MHTN
ARCHITECTS

Addendum No. 02

Project Name: **SJSD Albert R. Lyman Middle School**

Addendum No. 02 to the Construction Contract for the above-referenced project:

REFLECTED CEILING PLAN

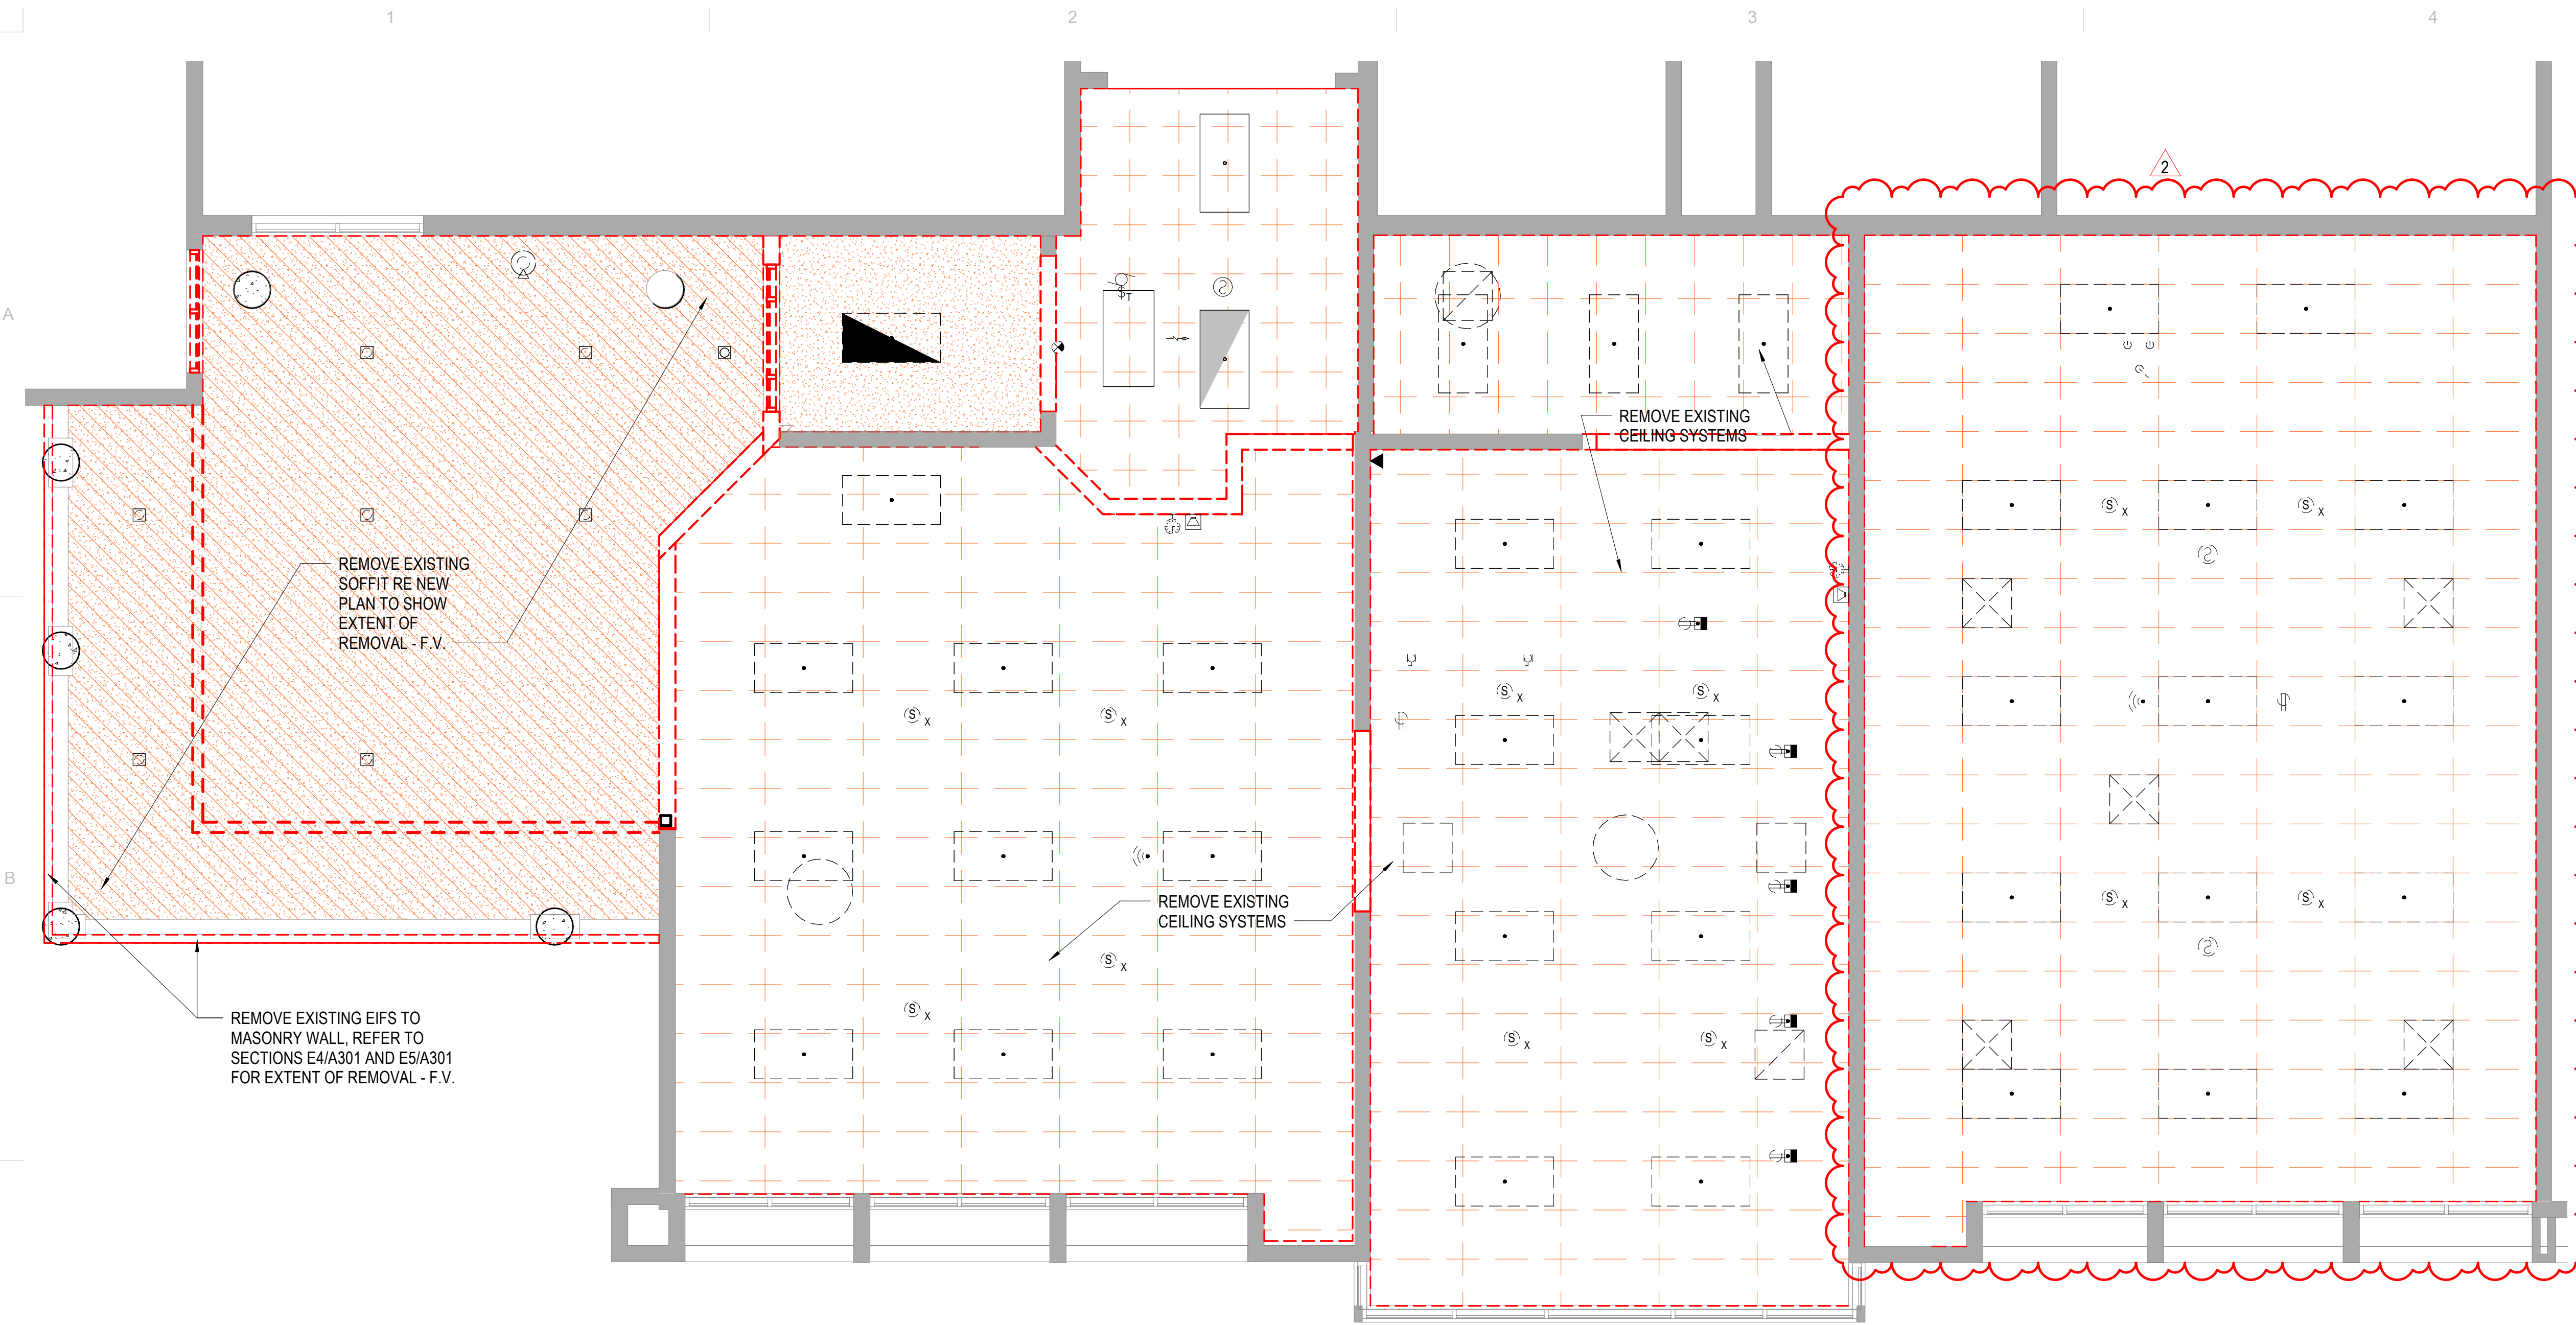
1. Increased overall scope to include replacement of ceiling in room A131
- A2.12 Sheet A701 – Admin RCPs
1. Increased scope to include removal and replacement of ceiling in room A131

MECHANICAL PLAN ADMIN

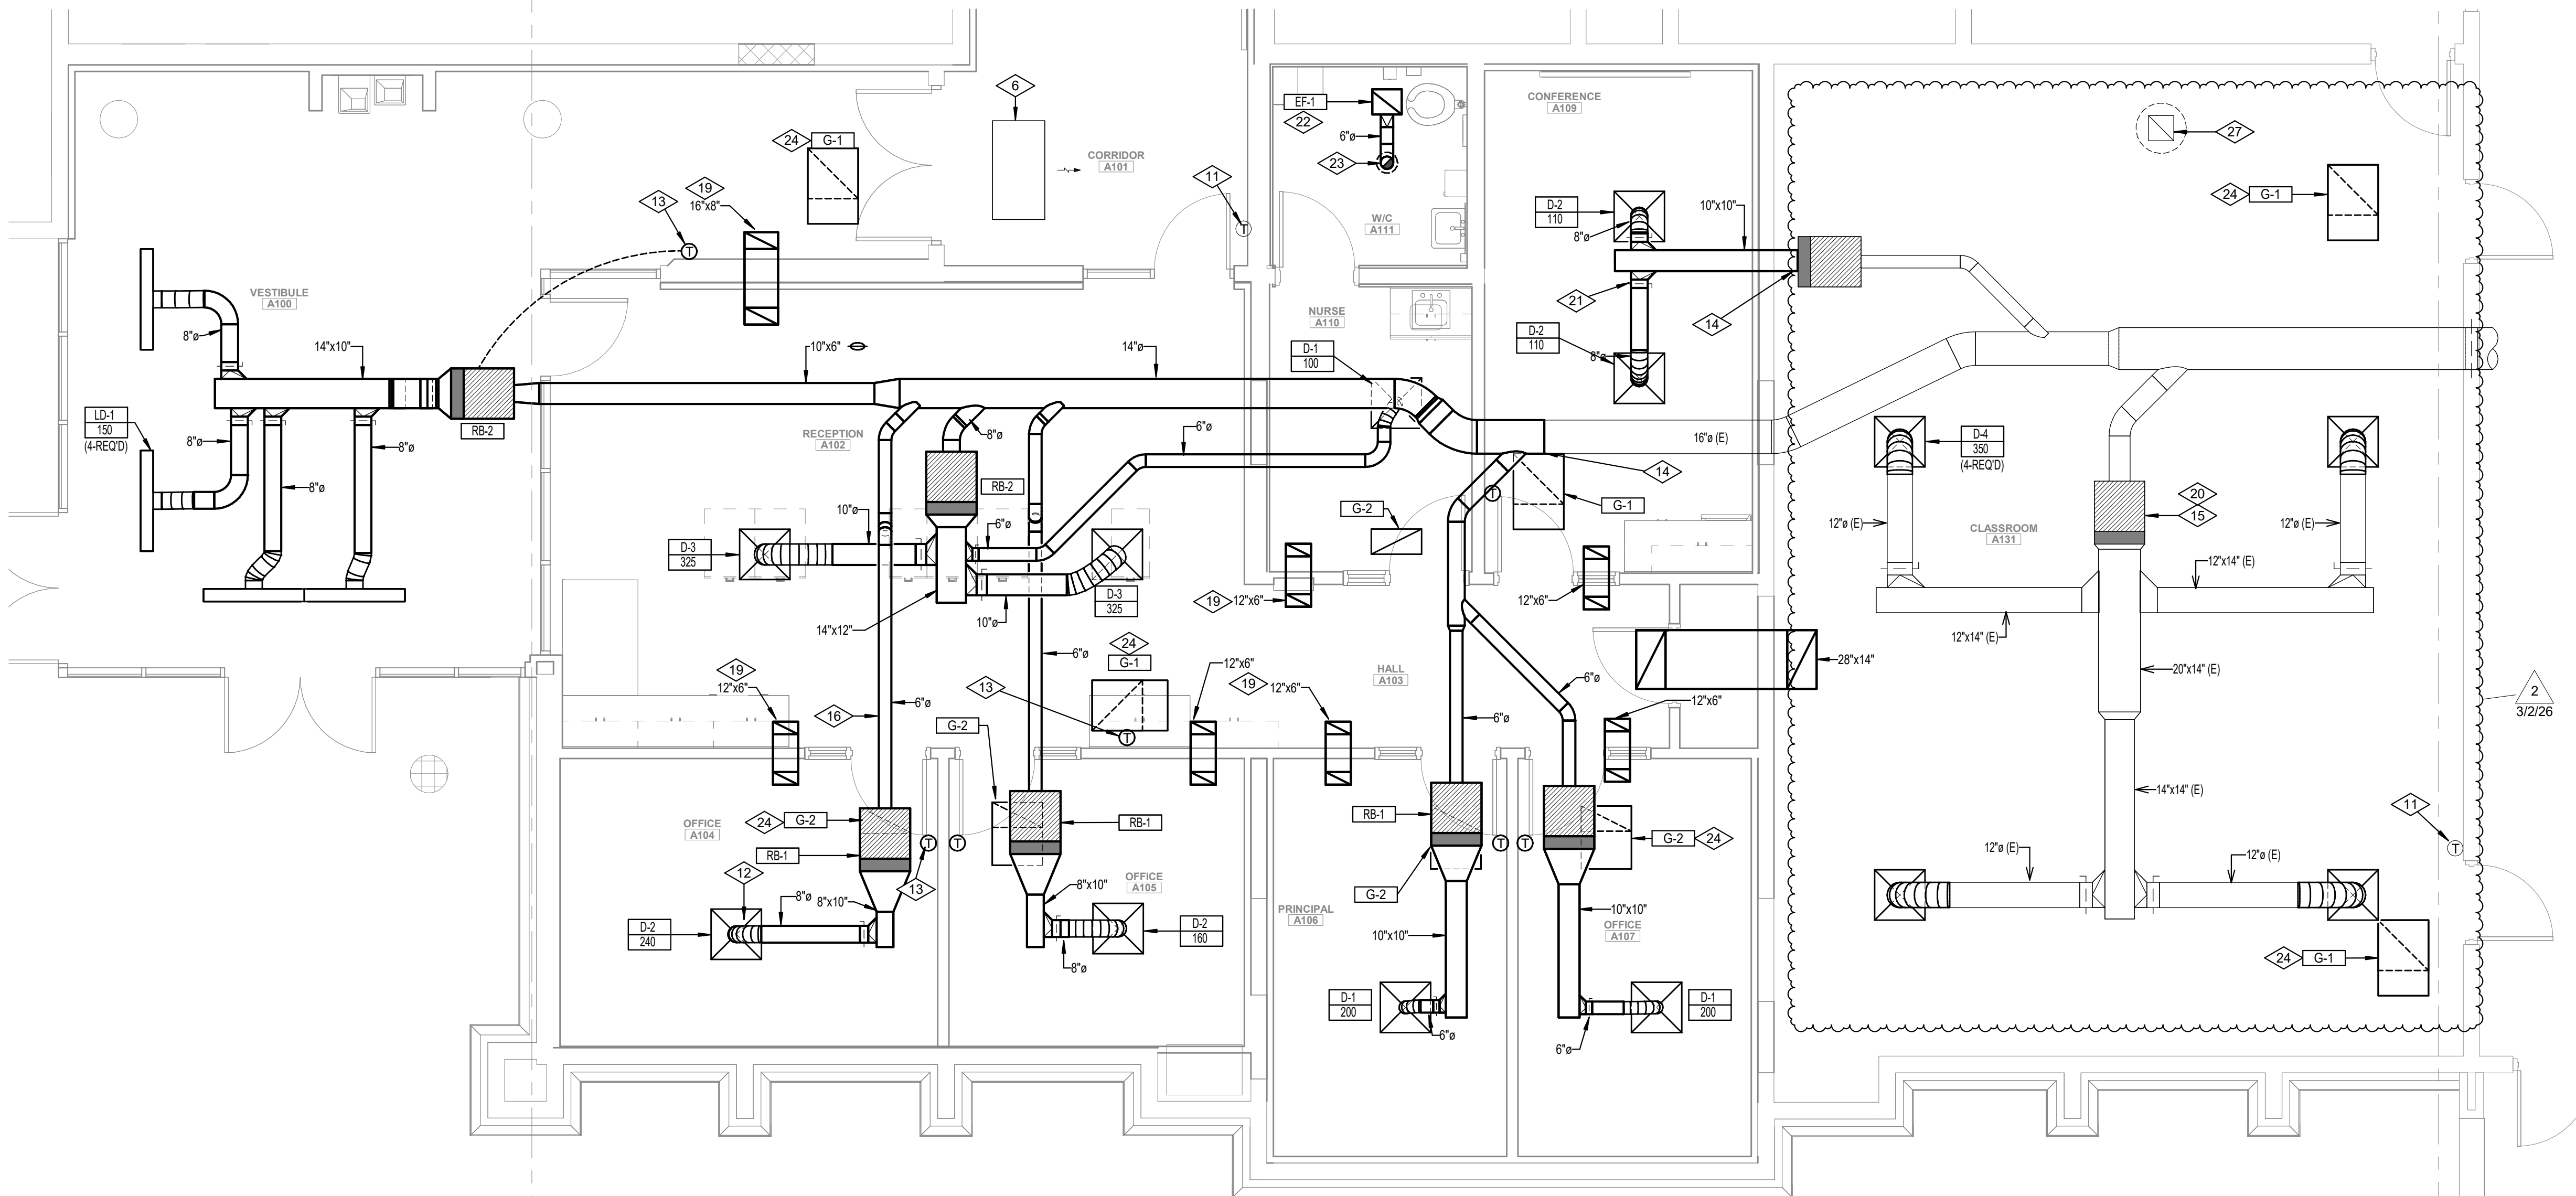
1. Classroom A131 has been added to the scope. No new mechanical equipment; includes removal and replacement of diffusers and grills into new ceiling system. See M101.

1 ADMIN AUDIO VISUAL PLAN
SCALE: 1/4" = 1'-0"

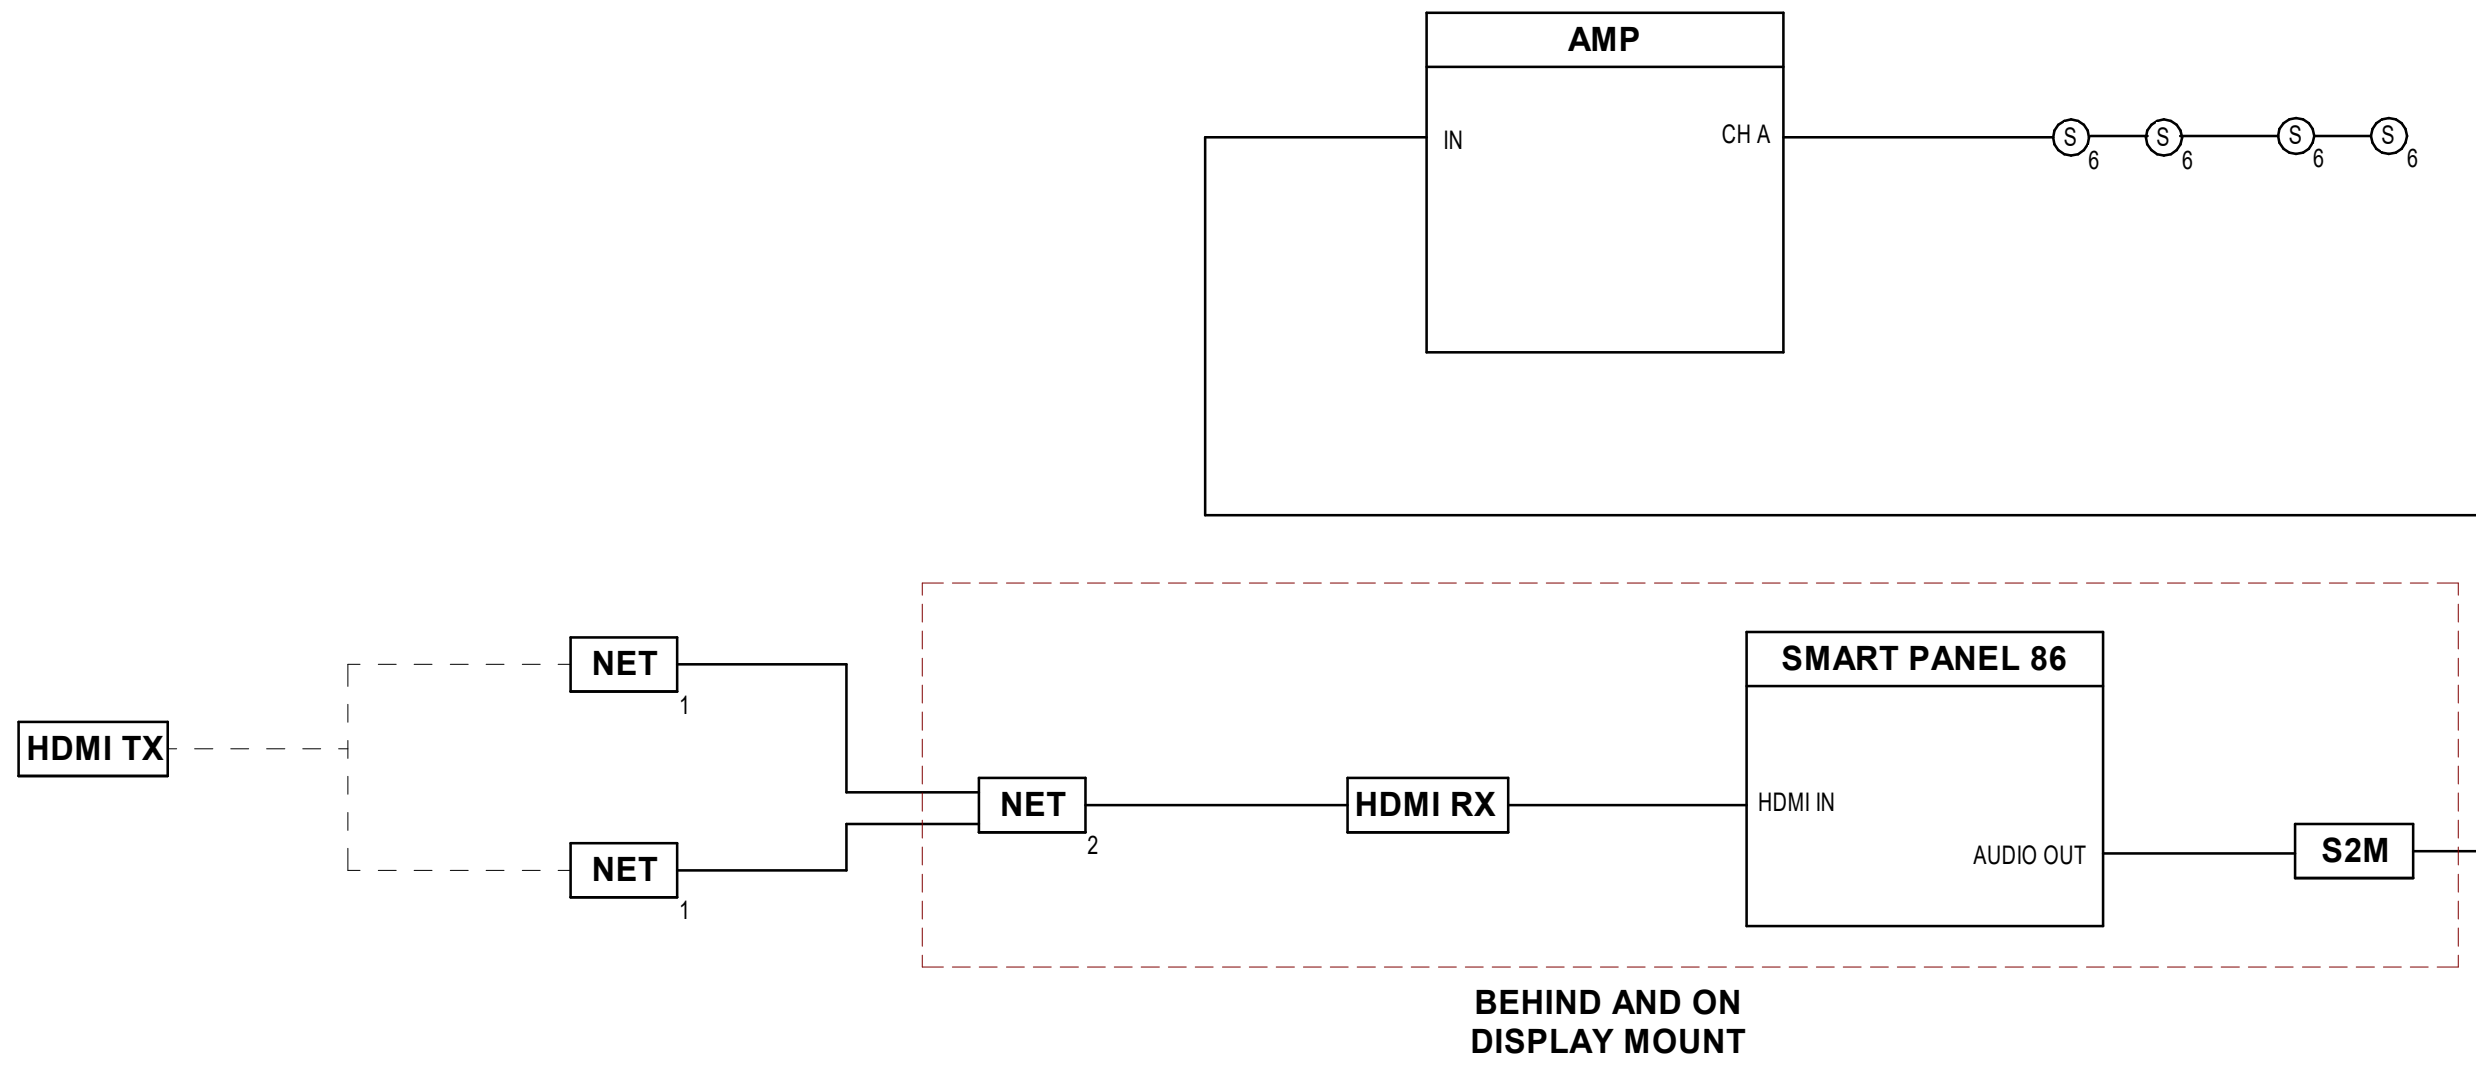
1. Refer to sheet for changes in Classroom X325
- E2.5 Sheet EP102 – Admin Power Floor Plan
 1. Refer to sheet for changes in Classroom X325
- E2.6 Sheet EP701 – Equipment Schedules and One Line Diagram – Power
 1. Panel P will now be fed from panel “EDP”
- E2.7 Sheet EP801 – Panel Schedules
 1. Panel P will now be fed from panel “EDP”
- E2.8 Sheet EY101 – Classroom Addition Systems Plan – Bid Alt 1
 1. Add callout referencing detail 3 on sheet EY702
- E2.9 Sheet EY102 – Admin Systems Plan
 1. Refer to sheet for changes in Classroom X325
- E2.10 Sheet EY702 – Access Control Door Rough-in Details
 1. Add detail #3 Double Door with card reader and electrified panic
- E2.11 Sheet EA101 – Admin Audio Visual Plan
 1. Refer to sheet for changes in Classroom X325
